**ZONING AMENDMENT  
& SUBDIVISION STAFF REPORT****Date: March 6, 2008****APPLICANT NAME**

The Moors at Springhill Subdivision

Subdivision approval to create 2 lots, and Zoning approval to rezone the site from R-1, Single-Family Residential, to B-1, Buffer Business, to allow professional offices.

# DETAIL SITE PLAN

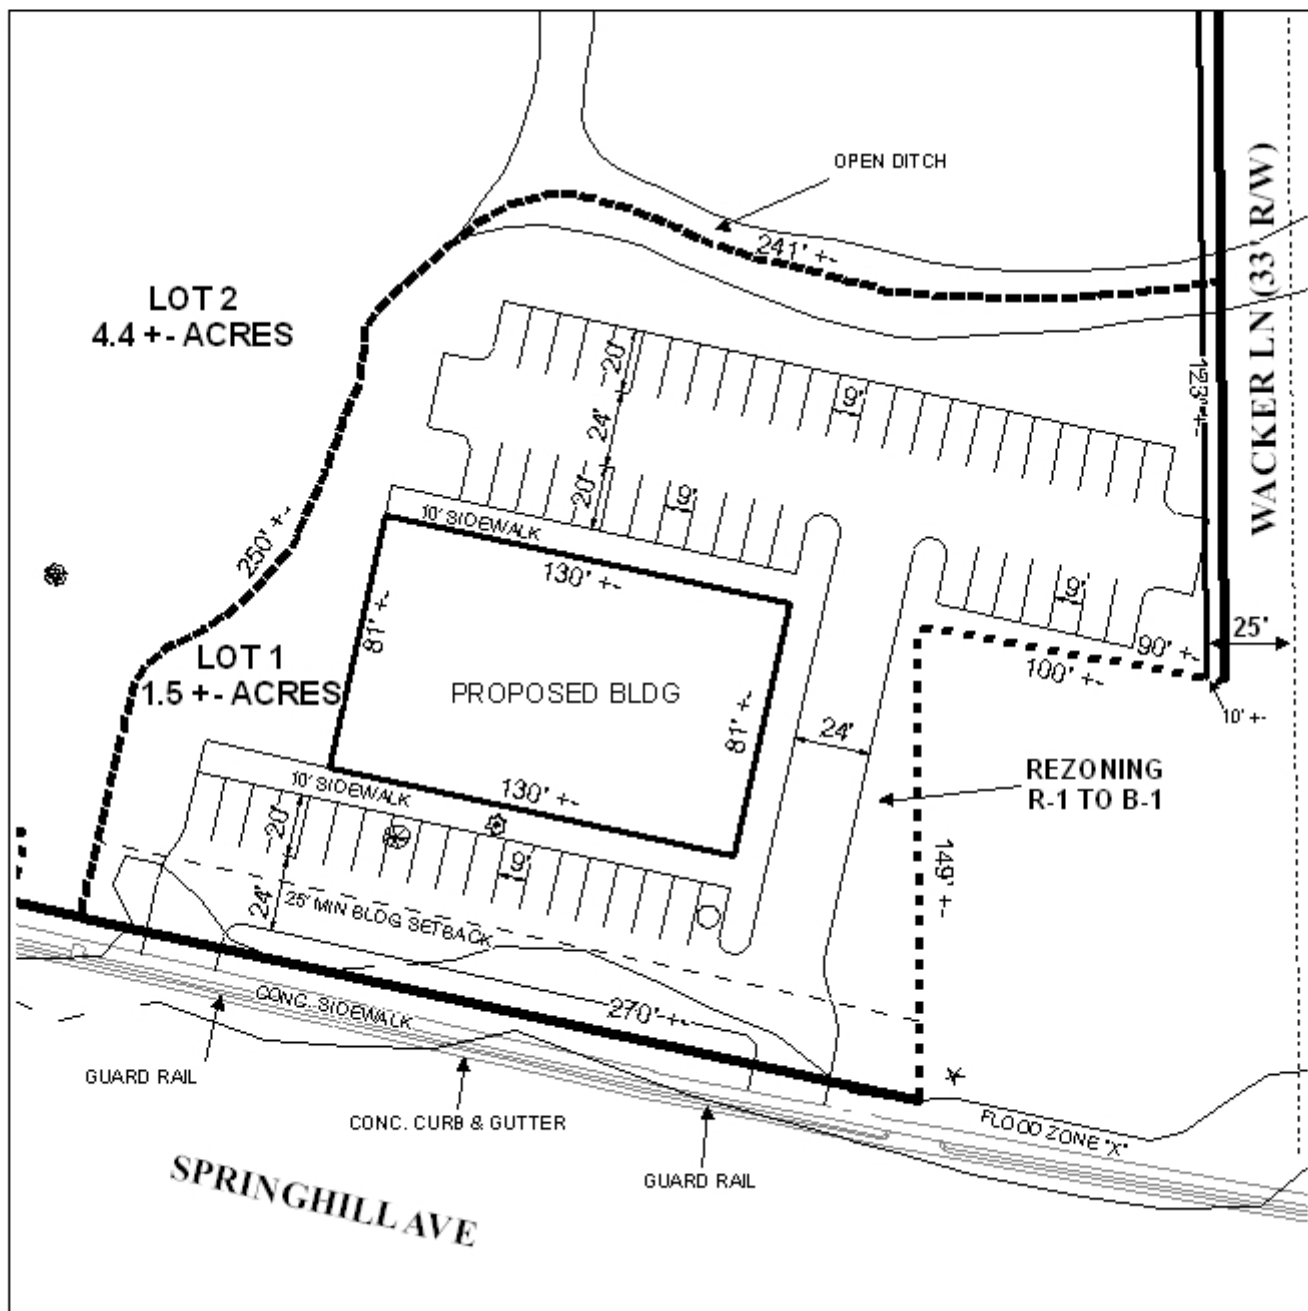
*The plat and site plan were also revised to depict dedication of right-of-way along Wacker Lane to provide 25-feet, as measured from the centerline, however the site plan was not modified regarding the recommended number of curb-cuts.*

- 4) Placement of a note on the final plat stating that Lot 1 is limited to one (1) curb-cut, to be aligned with the curb-cut on the South side of Spring Hill Avenue, that Lot 2 is limited to one (1) curb-cut to the service road, with the size, design and location to be approved by Traffic Engineering;
